TURKEY POINT NUCLEAR GENERATING STATION UNIT NO. 3

Amendment No. 38
License No. DPR-31

ATTACHMENT TO LICENSE AMENDMENT NO. 38
TO THE TECHNICAL SPECIFICATIONS
FACILITY OPERATING LICENSE NO. DPR-31
DOCKET NO. 50-250

SAFETY EVALUATION BY THE OFFICE OF NUCLEAR REACTOR REGULATION
SUPPORTING AMENDMENT NOS. 38 AND 31 TO LICENSE NOS. DPR-31 AND DPR-41
FLORIDA POWER AND LIGHT COMPANY
TURKEY POINT NUCLEAR GENERATING UNIT NOS. 3 AND 4
DOCKET NOS. 50-250 AND 50-251

FIGURE 3.2-3

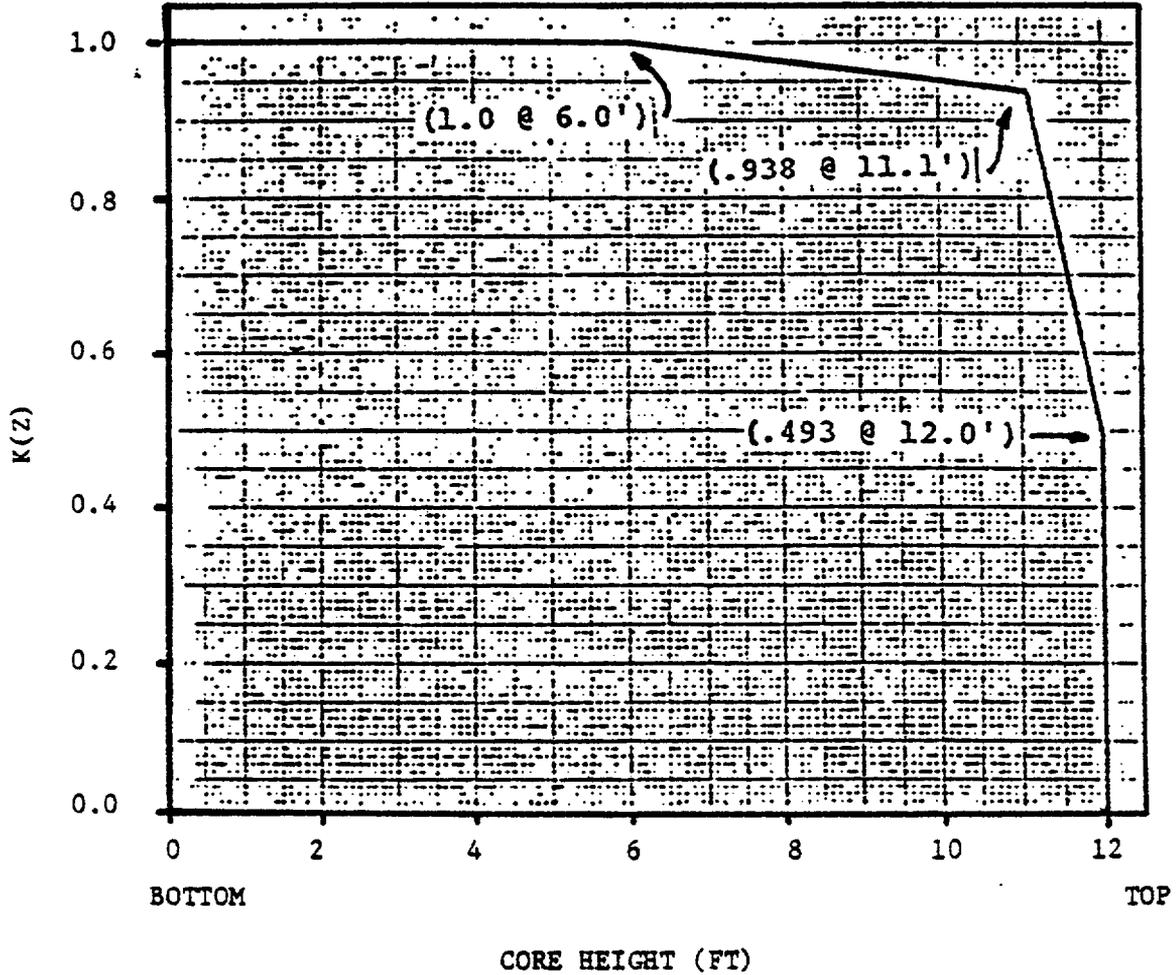
The normalized axial F_0 shaping factor (Figure 3.2-3) in the Technical Specifications has been changed consistent with the assumptions used as input for the LOCA analysis.

HOT CHANNEL FACTOR-NORMALIZED
OPERATING ENVELOPE (FOR STEAM
GENERATOR TUBE PLUGGING $\leq 25\%$ and $F_q = 2.03$)
